Whenuapai Wastewater Scheme – package 1 works

Meeting Notes and Actions

WHENUAPAI-REDHILLS WASTEWATER SERVICING PACKAGE 1
WASTEWATER PUMP STATION (DPISH)
EMERGENCY OVERFLOW PLAN & LONGITUDINAL SECTION

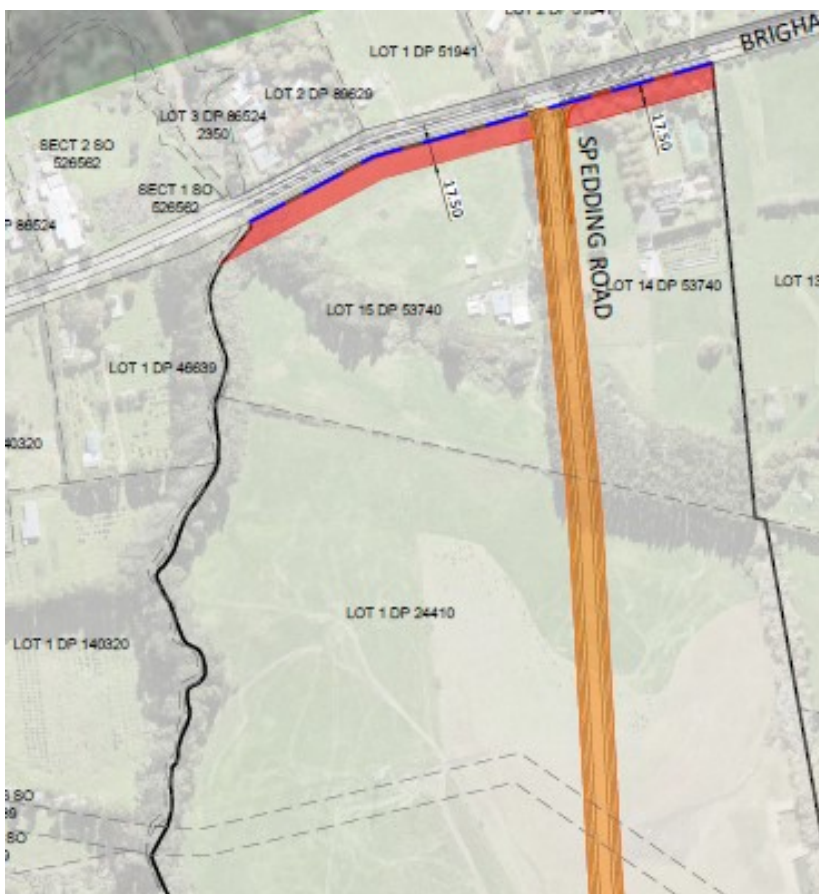
I note that the proposed alignment of Spedding Road within the Oyster Capital site, as proposed in Private Plan Change 69 is now looking like the diagram below.

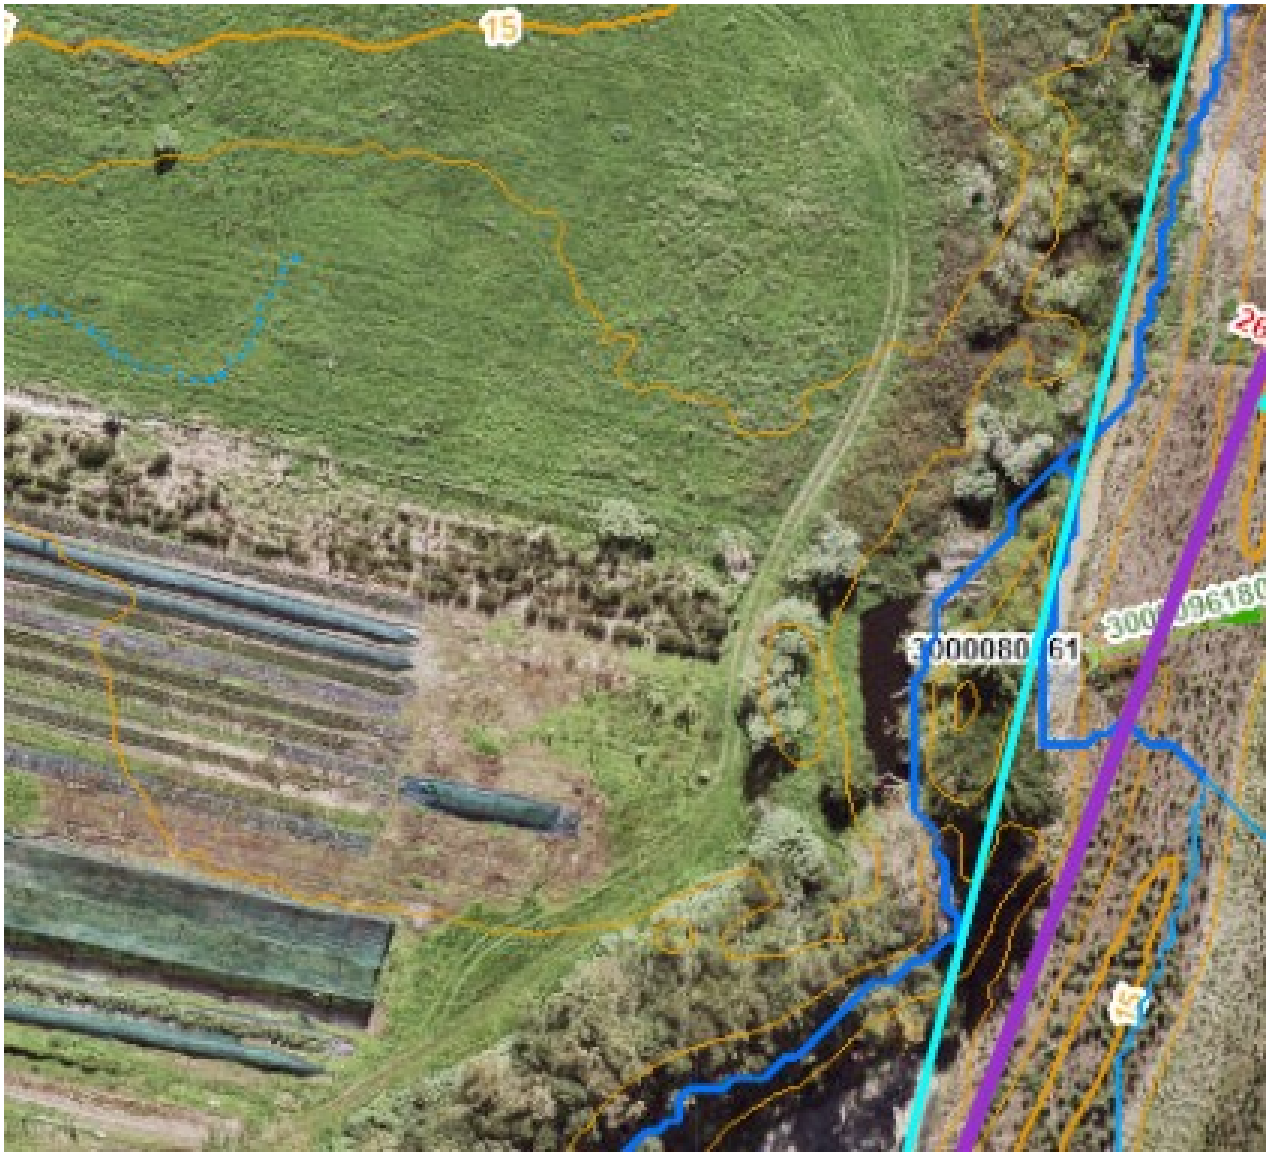
From the drawings you sent in your email below there doesn't seem to be much change in the alignment I have seen previously.

Whilst I can see that an adjustment to the designation has been made there does not seem to have been any changes to the actual pipe alignment which is still shown crossing through the area taken up by the embankment to the pond.

I've used GIS to sketch on a plan what my thoughts are on a more appropriate alignment, from a HW perspective and I've included this on the screenshot below.

The alternative route for the pipework is shown in yellow (the purple is the current alignment based on the drawings you sent to me on Wednesday)

I appreciate the yellow alignment would add approximately 48m and 2 manholes and there may:

- be an issue with maintaining self-cleansing velocities in the Wastewater pipe;
- be a possible clash with the 1350 diameter pond inlet;
- be additional construction costs.

However, the alignment in yellow would reduce both the construction and operation risk to the pond as follows:

- a. Construction access for the pipe is easier - being on relatively flat / gently sloping ground rather than on the slope between the creek and the pond.
- b. Risk of frack out / spill to the watercourse would be reduced for trenchless construction.
- c. Risk to the stability and integrity of the toe of the embankment to the west of the pond is removed both during and post-construction.

In addition, access for any maintenance / pipe replacements on the newly constructed wastewater pipe would be from the public road and not on a slope between the pond and the watercourse which would also reduce any environmental risk to both the pond and the watercourse during these works.

As the proposal stands, I cannot support the construction of a pipeline through or within the embankment of the pond.

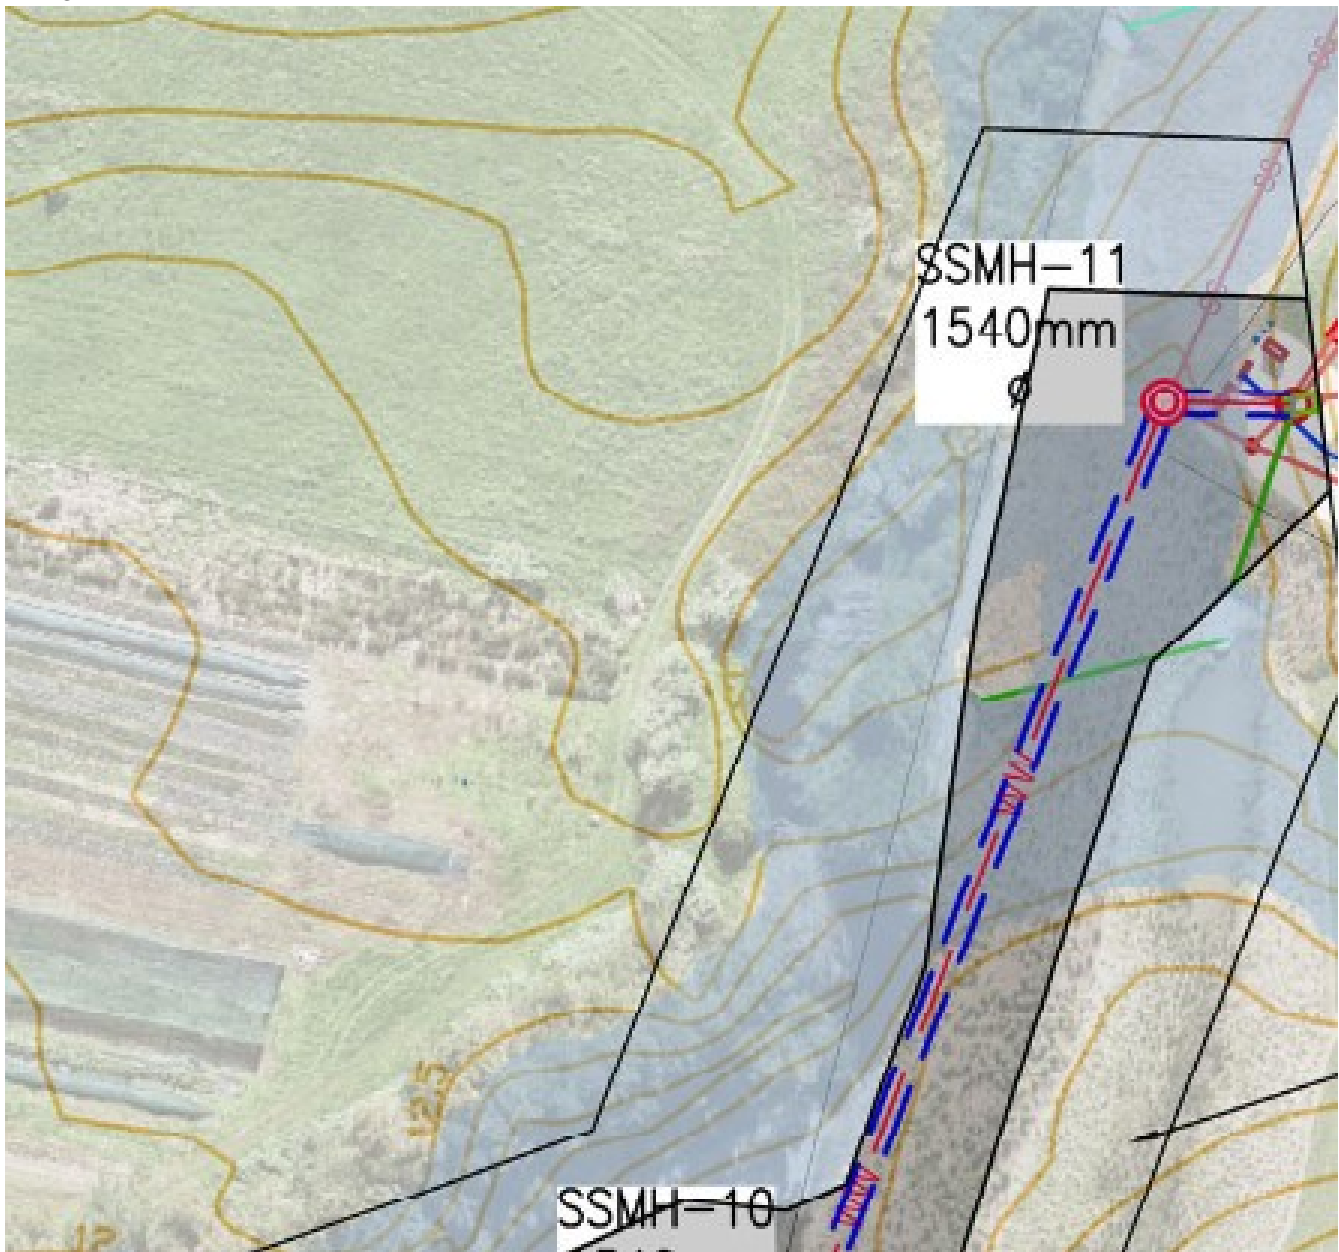
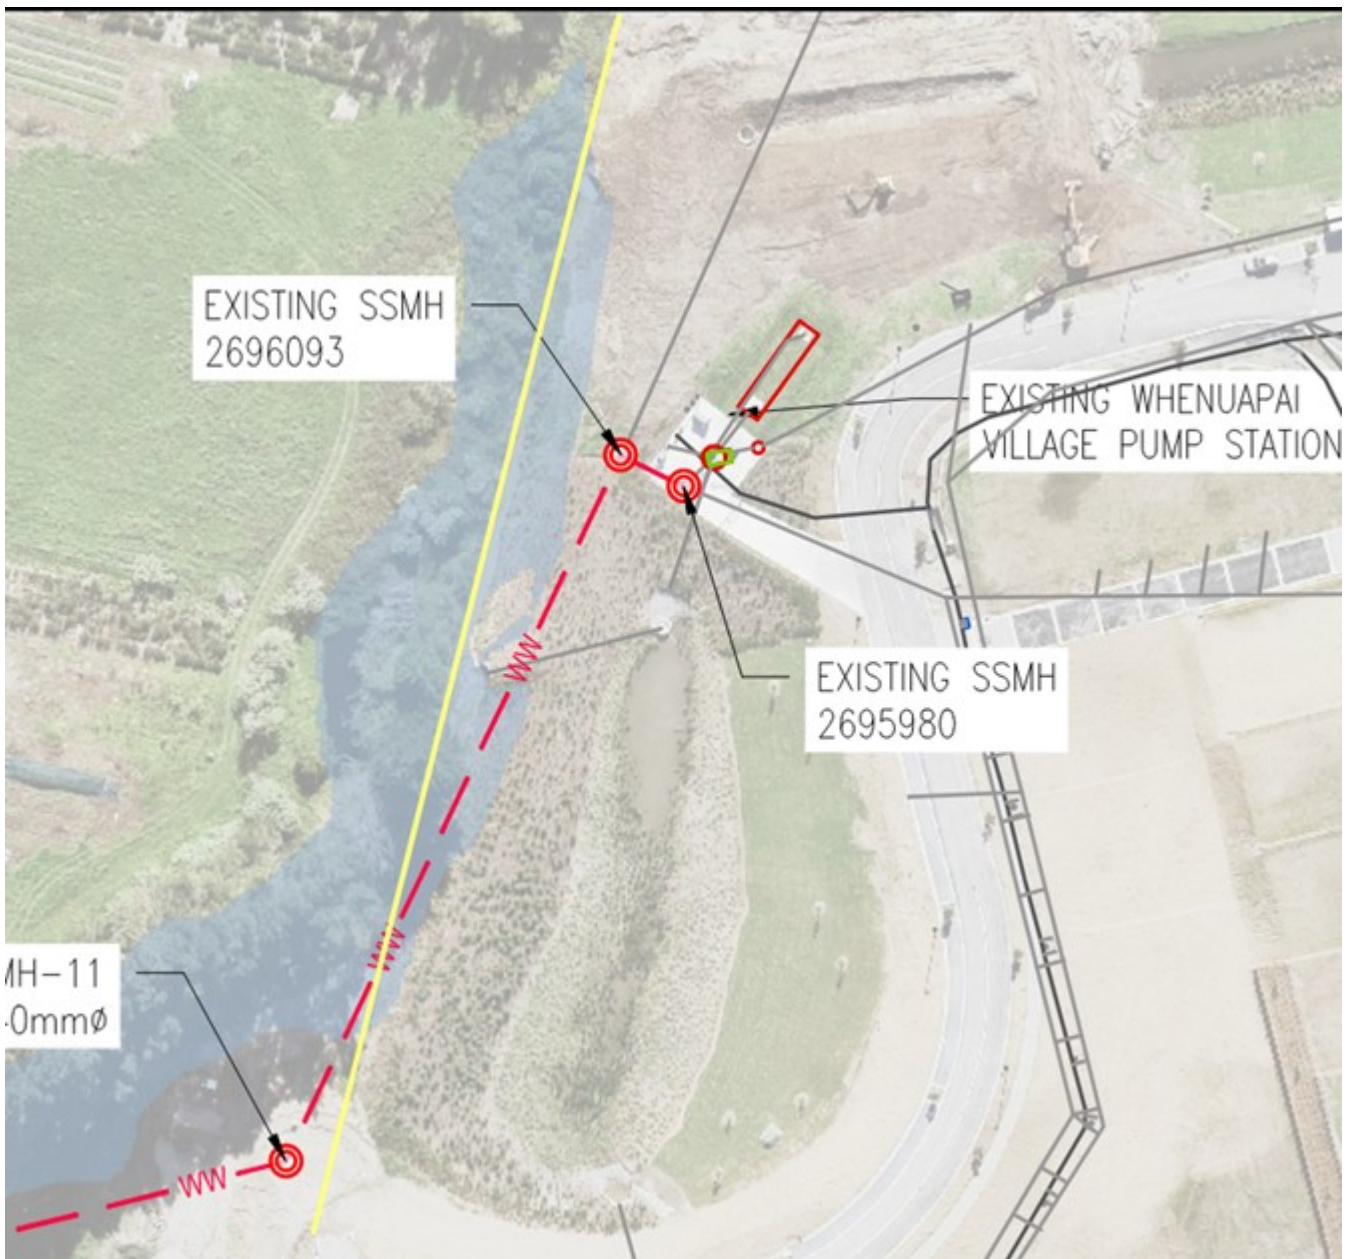
Please let me know if there is any further information that you require. But in the mean time please find below two images that outline the original design and changes that have been undertaken. Also attached are further documents about the project.

During the detailed design process, and in response to the Healthy Waters comment, the wastewater pipe has been shifted west, further away from the stormwater embankment. The pipe now crosses the property boundary into 28 Brigham Creek Road in order to avoid the embankment. Please see sketches below.

BEFORE:

AFTER:

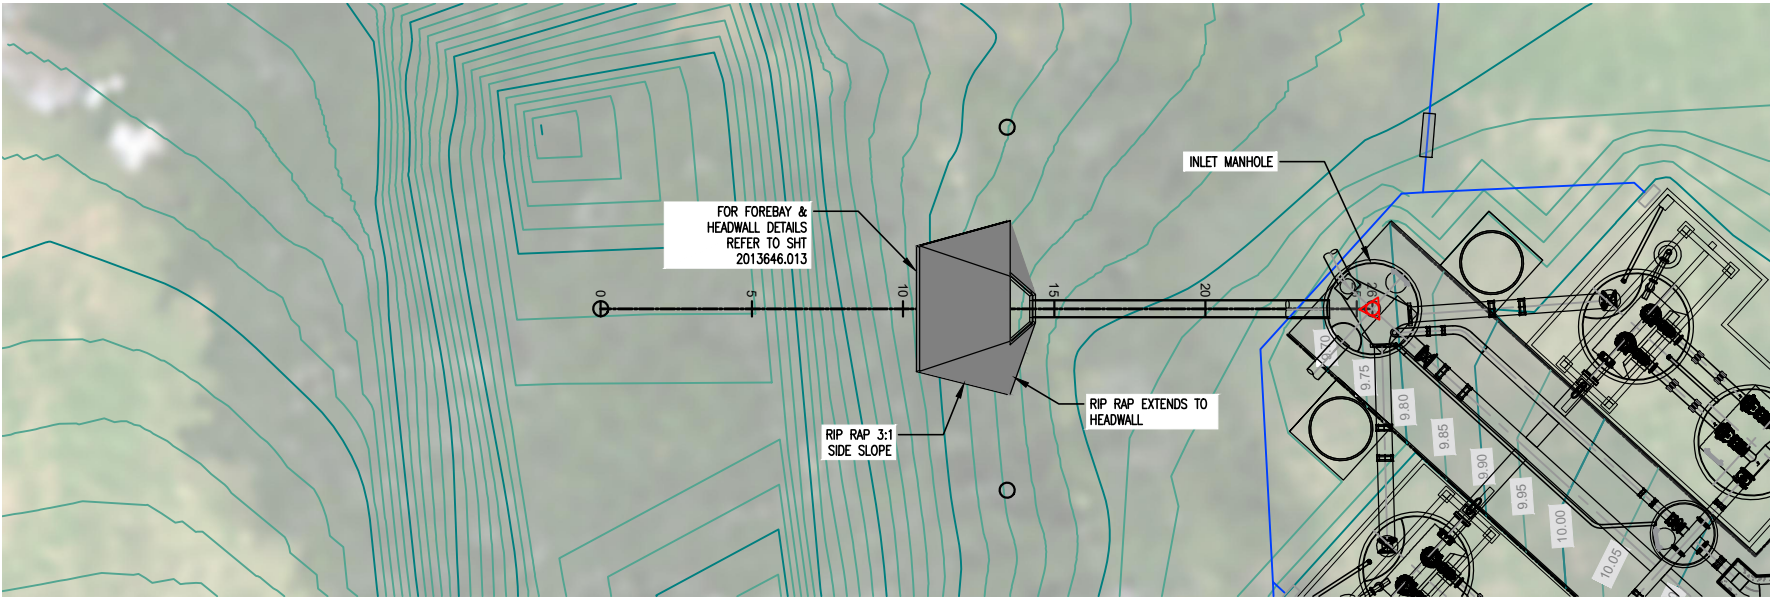
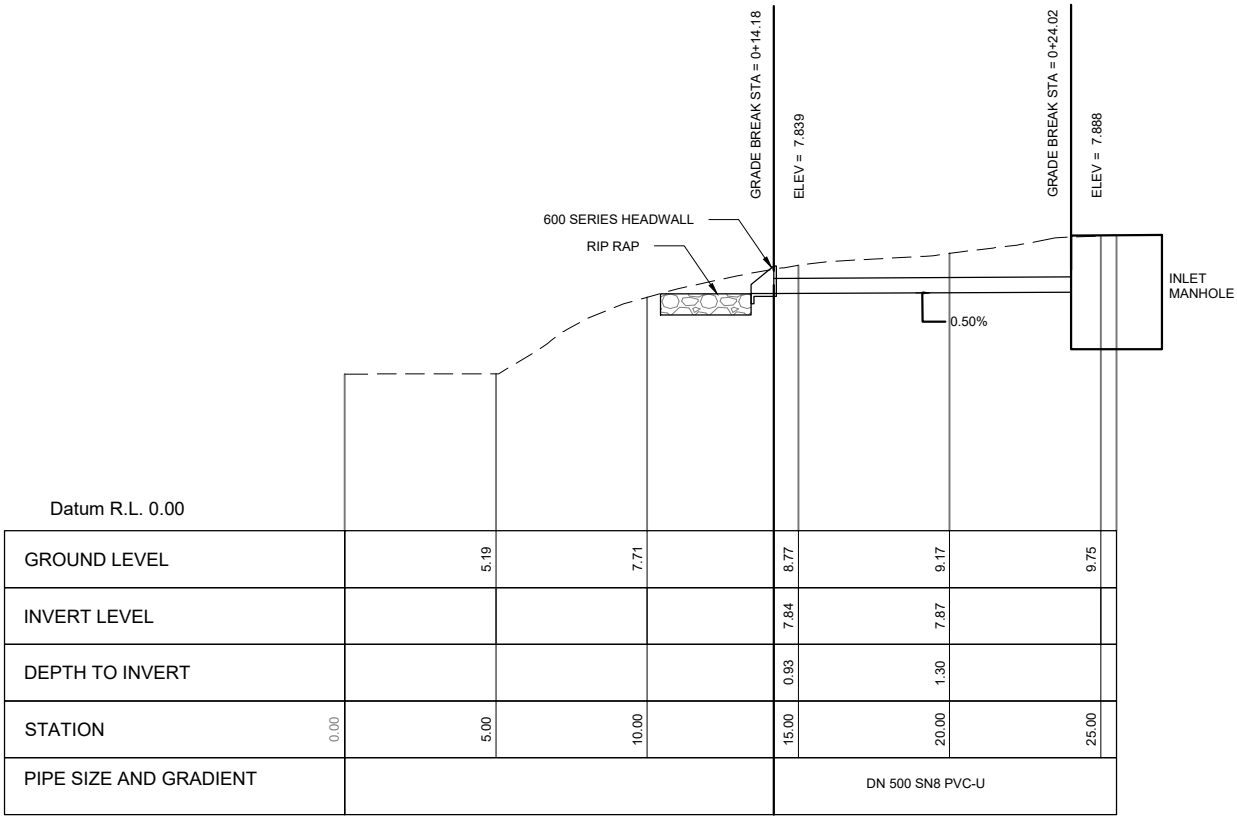
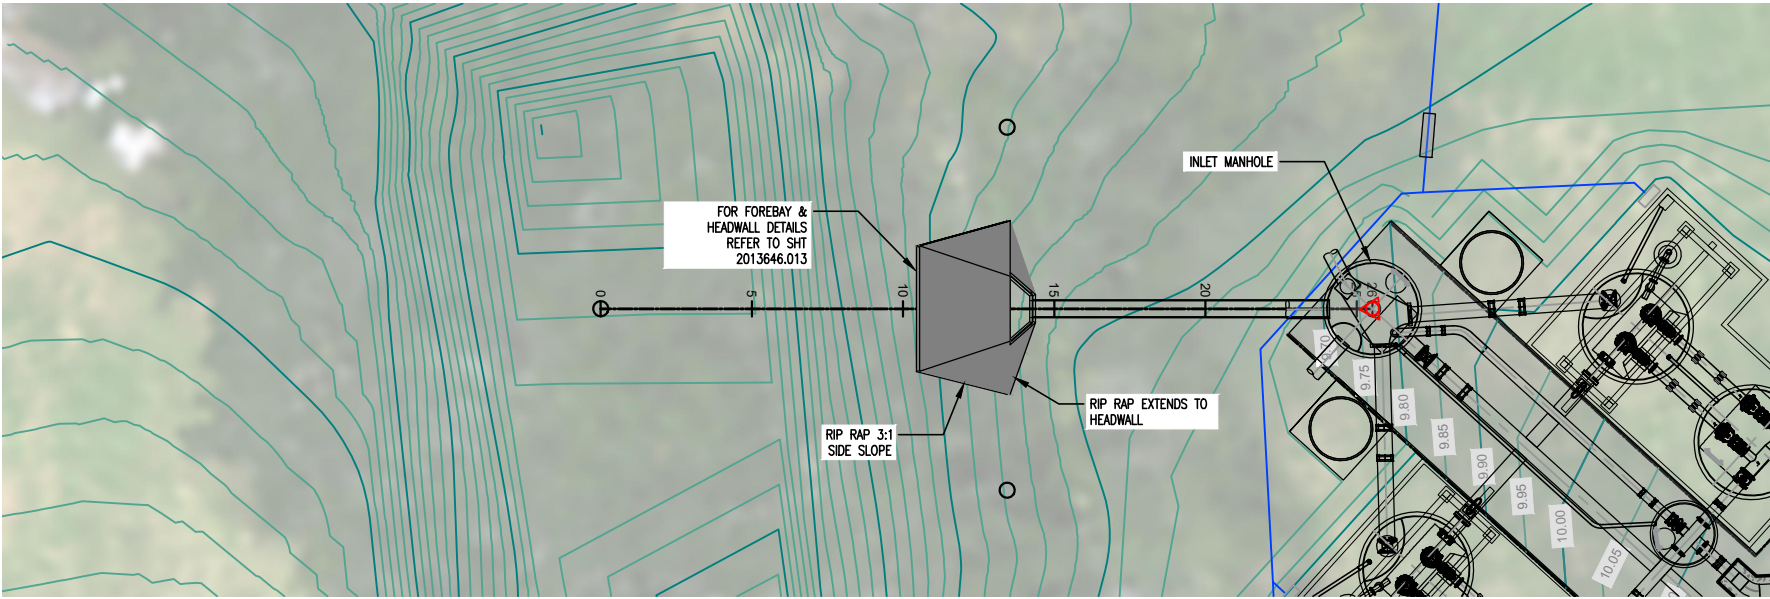
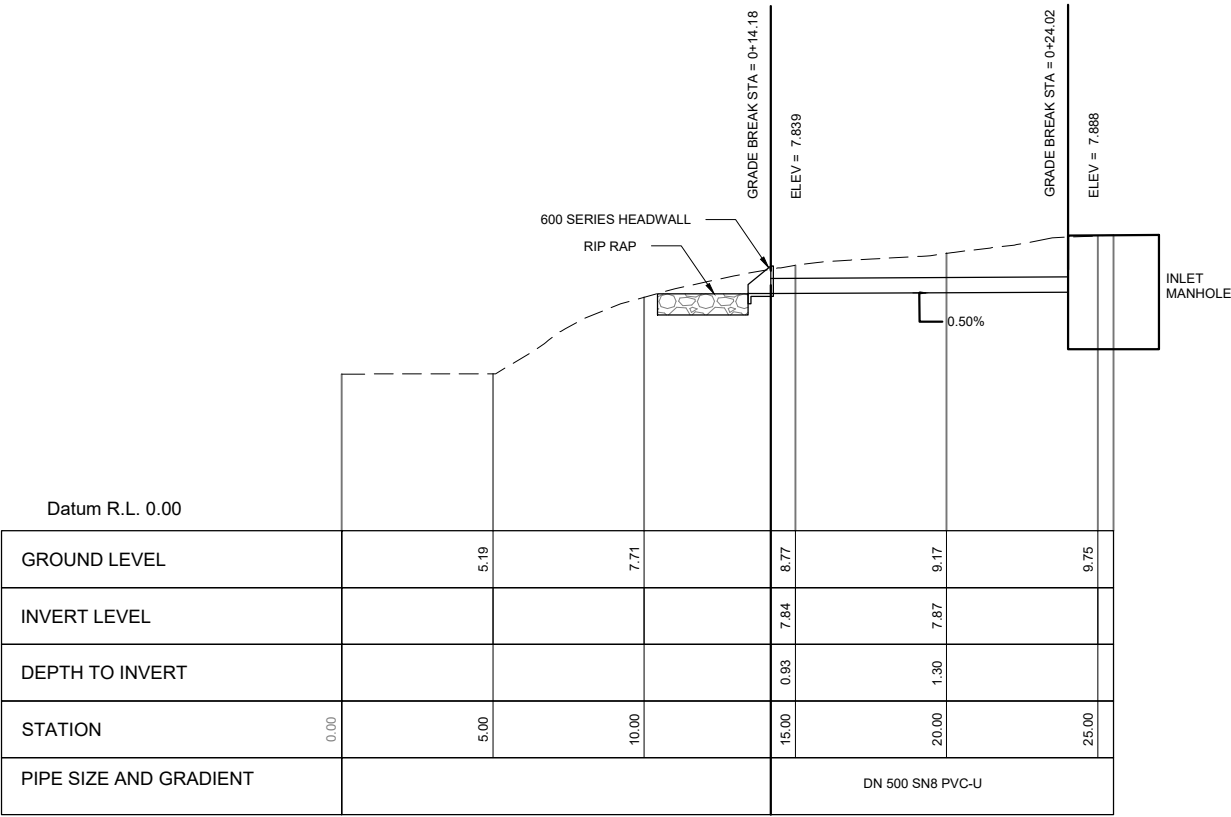
- EMERGENCY OVERFLOW PLAN & LONGITUDINAL SECTION as per drawing 2013646.012
- EMERGENCY OVERFLOW - OUTFALL AND RIPRAP DETAIL as per drawing 2013646.013

As detailed in the application information sheet, the requirements of this approval include the following:

- i. Telemetry is required on all new EOPs and is expected to be live.
- ii. Healthy Waters will be provided with this live information covering overflow occurrences, timeframe of occurrences and any other relevant telemetry information Watercare has on the EOP.
- iii. The EOP connection is expected to display in the Council GIS system within 30 days of construction completion
- iv. Clean up of overflows shall be the responsibility of Watercare to the satisfaction of the HW area operations manager.
- v. Where the overflow extends to private watercourses or other open environments, Watercare will manage the effects and respond to any complaints.
- vi. Screening is to be installed on overflow weirs to mitigate debris where possible.

Any changes to the design will need to be resubmitted and re-approved.
